VILLAGE OF DOWNERS GROVE
Report for the Village
1/12/2021

SUBJECT:	SUBMITTED BY:
Belmont Bible Church, 5416, 5418, 5430 Belmont Road, and 2097 Inverness Avenue – Annexation, Zoning Ordinance Map Amendment and Special Use	Stan Popovich, AICP Director of Community Development

VILLAGE OF DOWNERS GROVE
REPORT FOR THE PLAN COMMISSION
DECEMBER 7, 2020 AGENDA

SUBJECT:	TYPE:	SUBMITTED BY:
20-PLC-0014 Belmont Bible Church	Annexation, Zoning Map Amendment, and Special Use	Gabriella Baldassari Development Planner

Proposed Plan

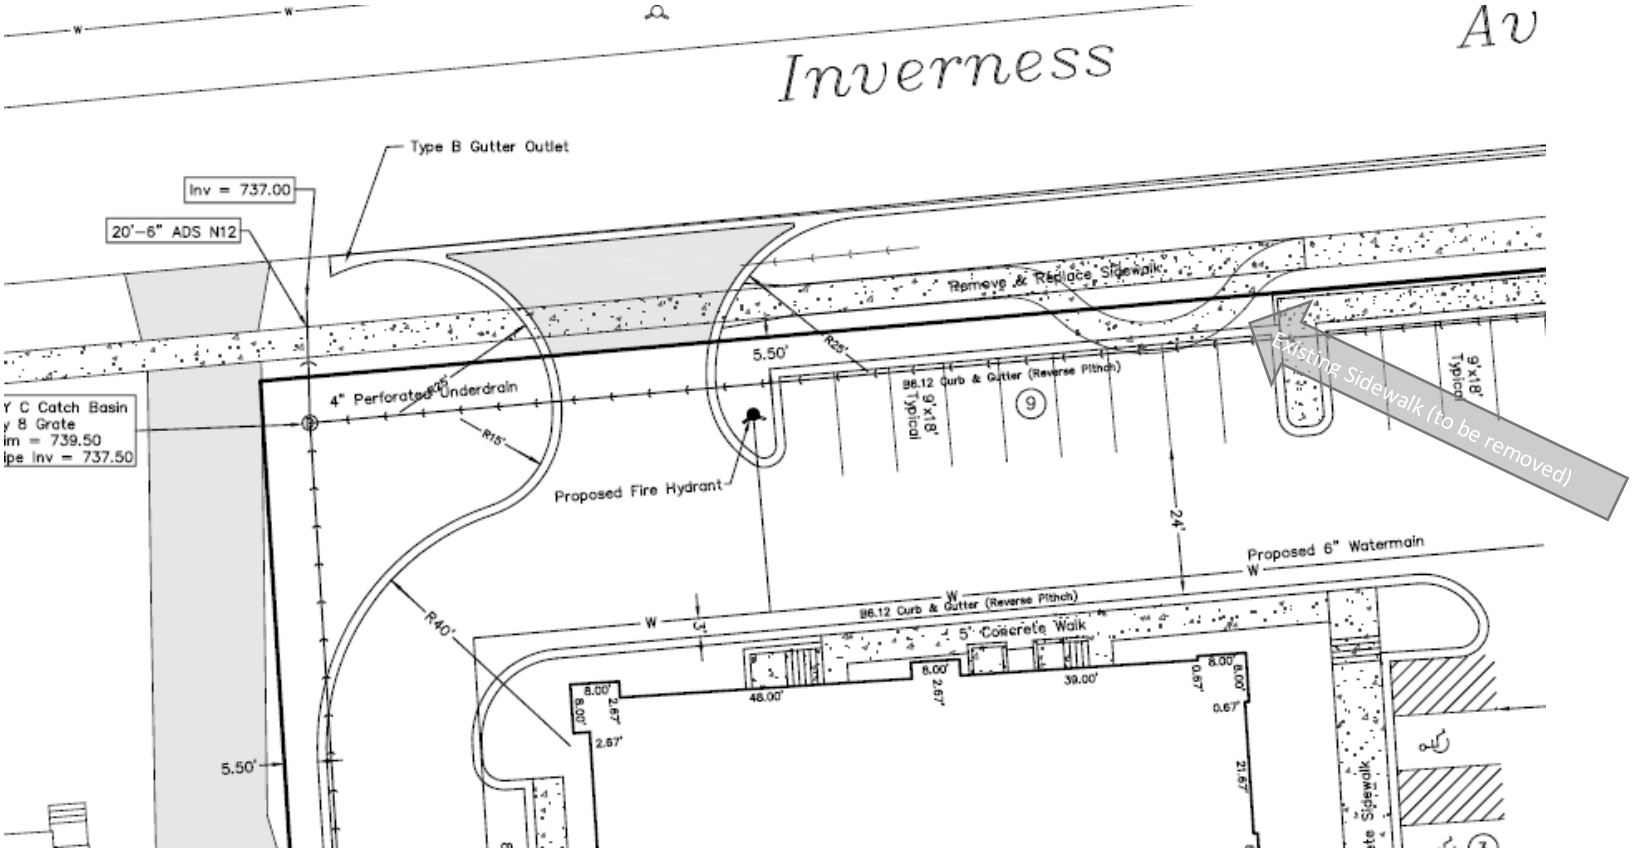
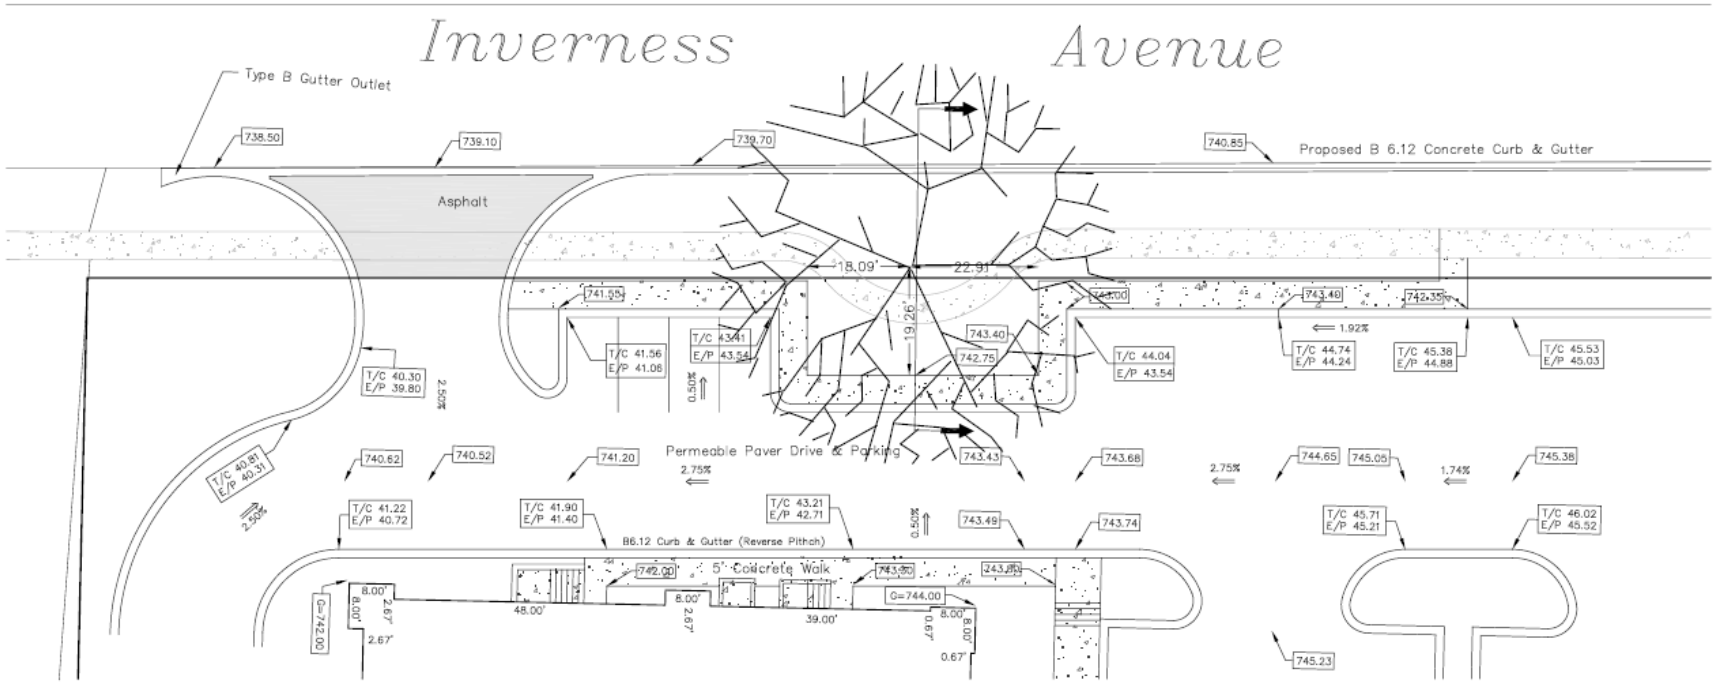
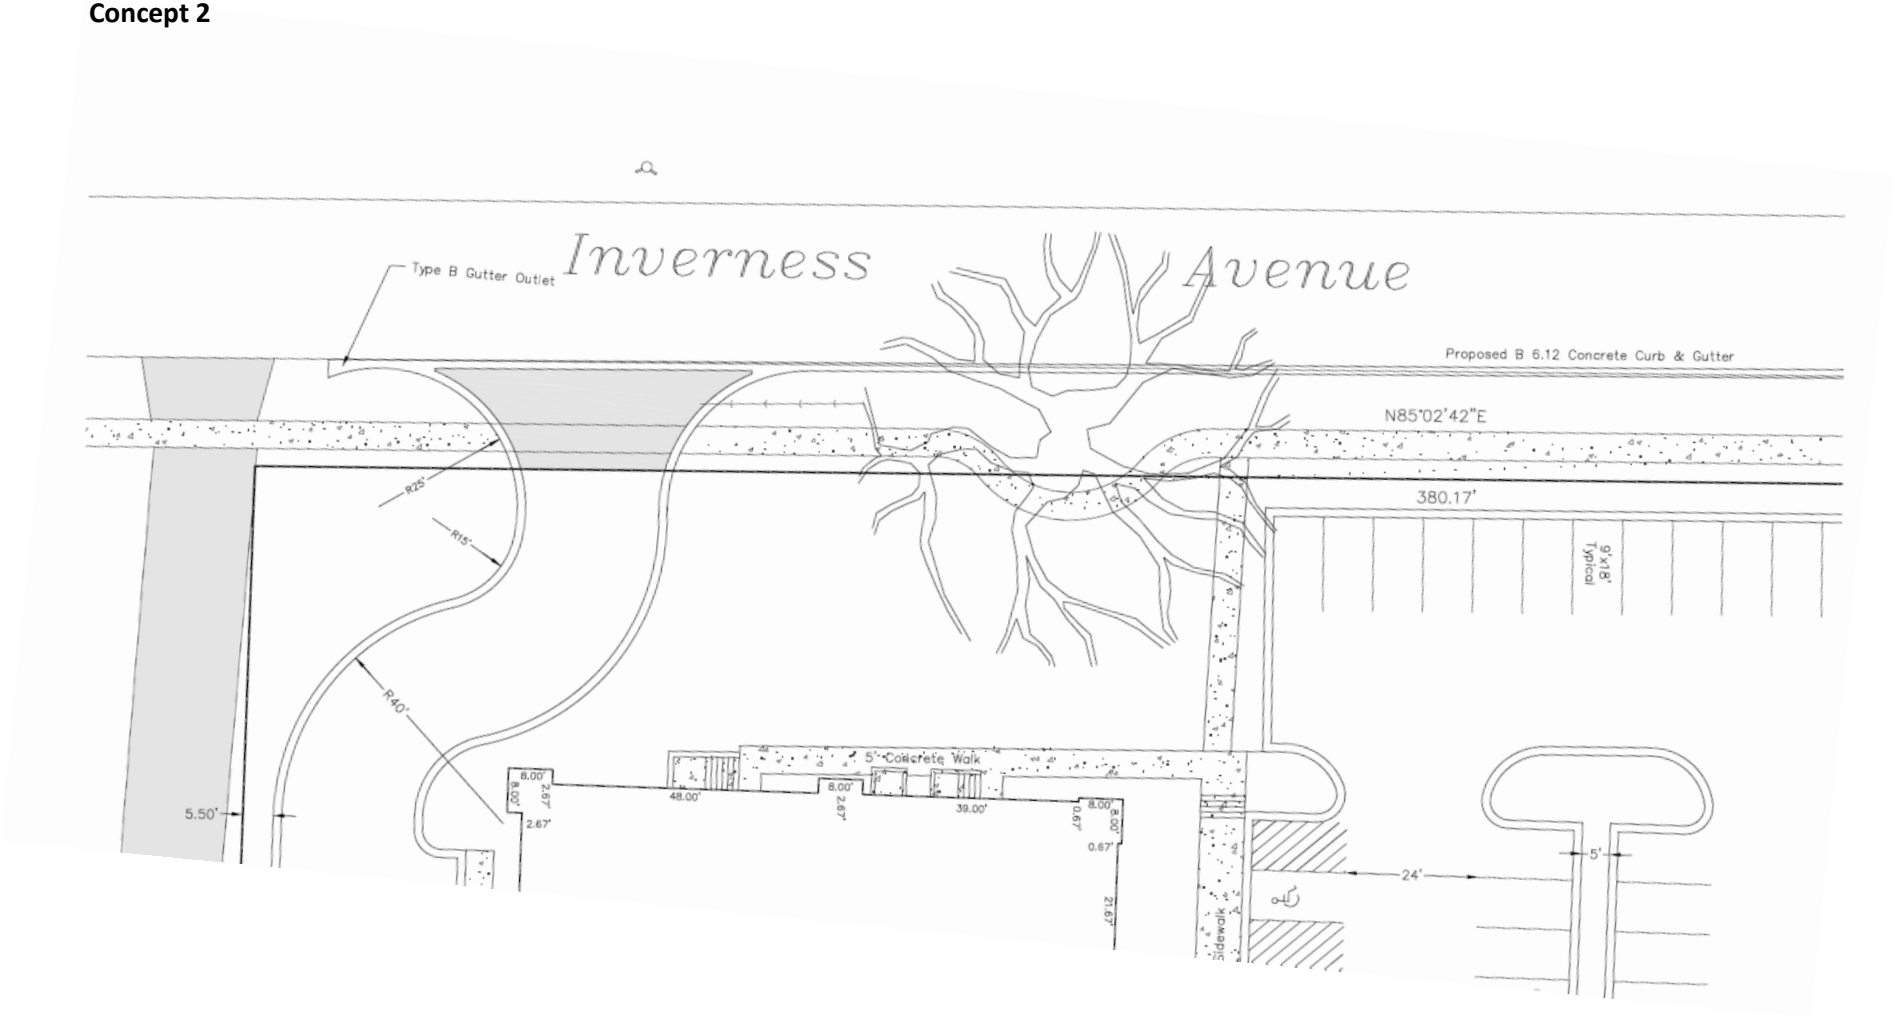
Further discussed under "Public Comment", prior to the Plan Commission meeting, staff did receive communication from a resident who was concerned about the removal of a honey locust tree located in the Village's Inverness Avenue right-of-way. The petitioner provided two additional concept site plans showing how the site could be developed if the honey locust tree remains. In both concept site plans, the petitioner thinks that the tree will not survive because of the impact of the right-of-way and parking lot improvements on the tree's root system. The Village forester concurs with this opinion.

- Concept 1 - This concept relocates the sidewalk south of the tree, while maintaining the 24 foot wide parking lot drive aisle to allow full circulation around the building. Five parking spaces would be lost.

- Concept 2 - This concept removes the 24 foot drive aisle and all parking spaces north of the building. This will result in a loss of nine parking spaces and full circulation around the building will not be maintained.

The petitioner prefers to remove the tree and construct the project as shown on the original site plan. The petitioner will be required to plant 12 new parkway trees, with an initial 2.5 inch caliper, and pay approximately $4,000 for the cost of the existing tree, per Village Code.
